# B-151456 - Grading

LEGALIZE 11000 CU. YDS. IMPORT FILL IN FLOOD ZONE

RE: Illegal Fill at Adobe Lumber, 5400 Old Redwood Highway

## RE: ADOBE LUMBER GRADING PERMIT

# **CITY OF PETALUMA FLOODWAY & FLOODPLAIN AREAS**

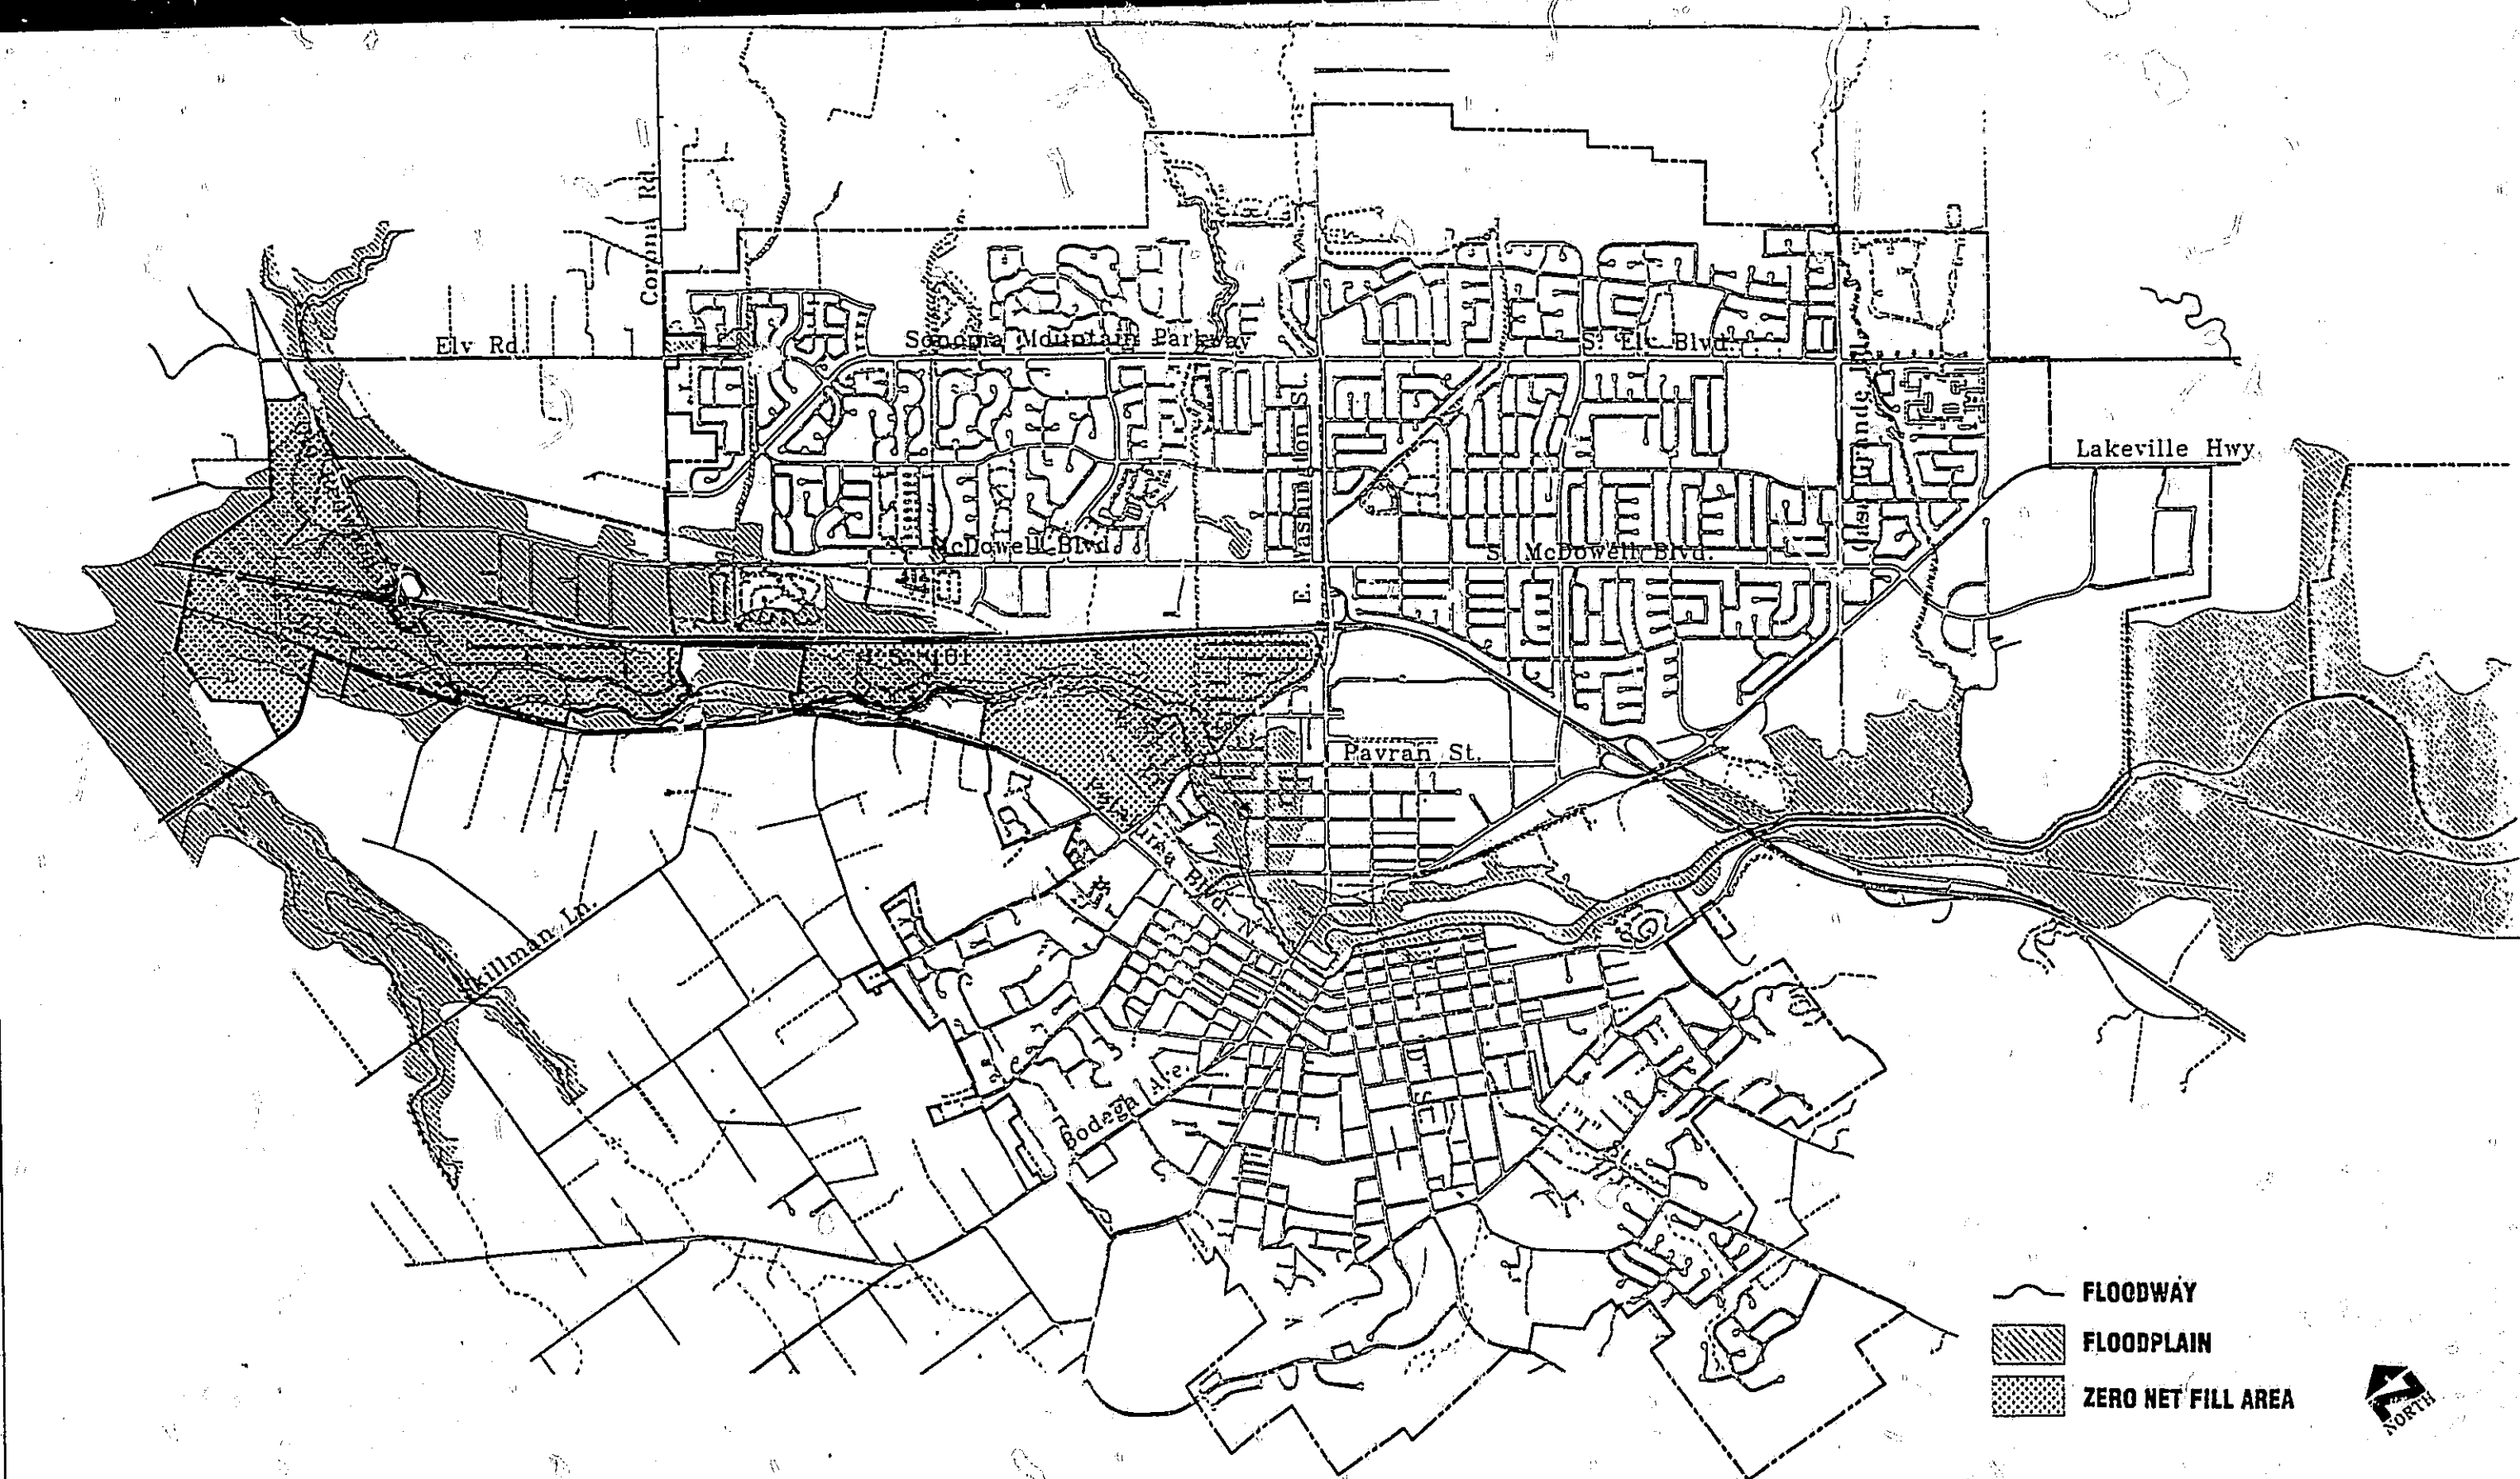
It is the City's position that the illegal fill that has been placed on the above noted property could have adverse impacts (flooding) to nearby properties within the city limits. In addition, we believe that adherence with the City of Petaluma "zero-net-fill" regulations would not permit the illegal fill. As has been requested by the City in past letters, please take immediate action to cause the fill to be removed (see attached, letter from Petaluma City Manager, Fredrick Stouder). The Sonoma County Permit and Resource Management should respect and require adherence with these regulations on the subject site.

Due to potential impacts to the City of Petaluma, the City is also requesting that the county provide documentation indicating that this grading and fill is compatible with the Sonoma County Water Agency Master Plan and/or Future Willow Brook Capital Improvement Projects prior to issuance of any permit.
